## **THE BAY RESORT, ANNA BAY OBJECTION**

**6/5/2021**

Review of the amended EIS still highlights many areas of concern for the proposed “The Bay Resort, Anna Bay.”

**Figure 23 Proposed upgrade of Nelson Bay Road intersection**

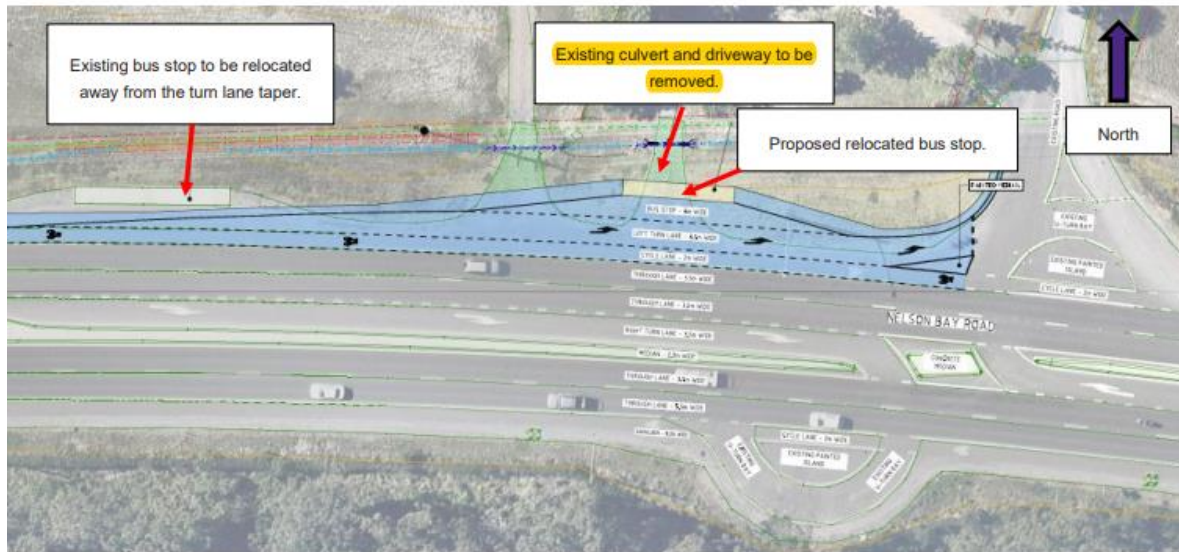
Comment: This upgrade denies legal front access to property 4181 Nelson Bay Road. This access has been in use since 1984. This again shows no consideration to adjoining landowners and the lack of technical expertise exercised, consultation or care in developing the proposal.

**Figure 18 Viewpoints selected for analysis.**

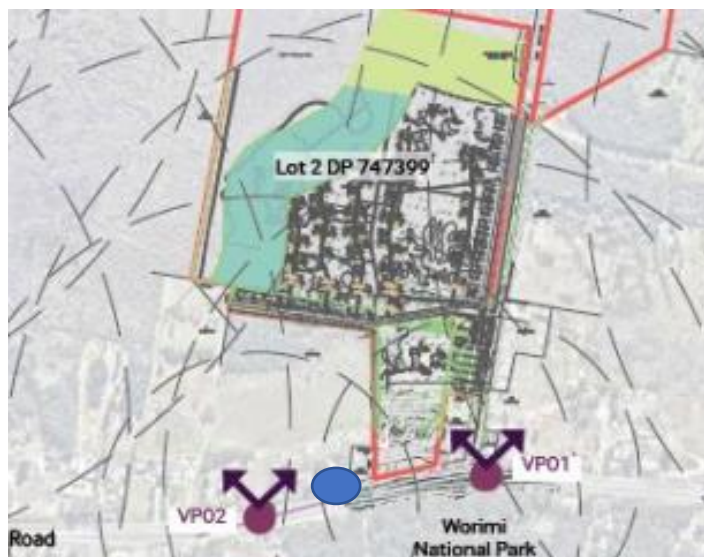
View-Point 1 is not in correct position on the location map, therefore it gives a misleading perspective. The blue dot shows the actual position the supposed views at View Point 1. The views represented are completely different from those that would be obtained at VP01.

View-Point 3 and 4 are 2km away from proposed site.

View-Point 6 is 1.5km from proposed site.

View-Point 5 is 5km from site.

View-Point 3,4,5 and 6 are all shielded by vegetation and topography from proposed site.

There are no view-points from adjoining rural properties ie 4165, 4181, 4183, 4187 Nelson Bay Road. These will be the most visually affected and their visual amenity dismissed.

Note: Areas in black show existing standing water

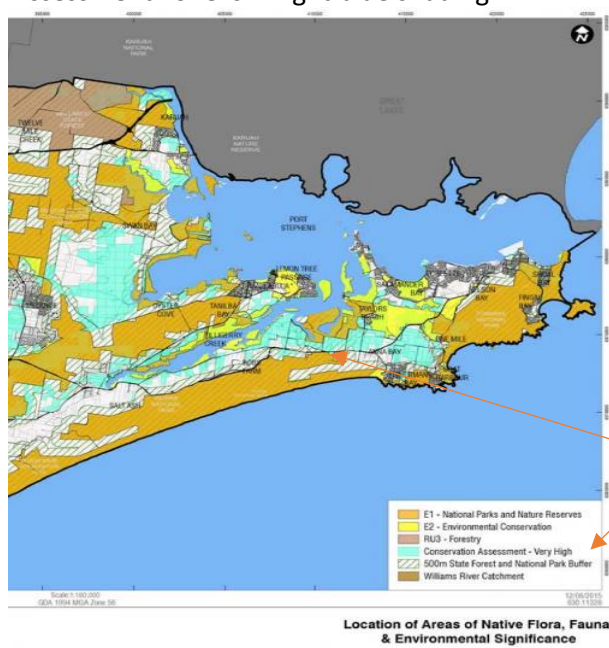
Comment: Having lived adjacent to the proposed site for over 60 years, I am witness to the fact that since the removal of the flood gates, the site has been regenerating naturally to saltwater marsh. It does not need human intervention in the form of a supposed eco-tourist complex. This can be supported by the EIS extract shown below which shows multiple areas of standing water in areas once containing agricultural pasture. See also Page 13, Paragraph 7

In addition, mosquito control will also be an issue with the large areas of standing water.
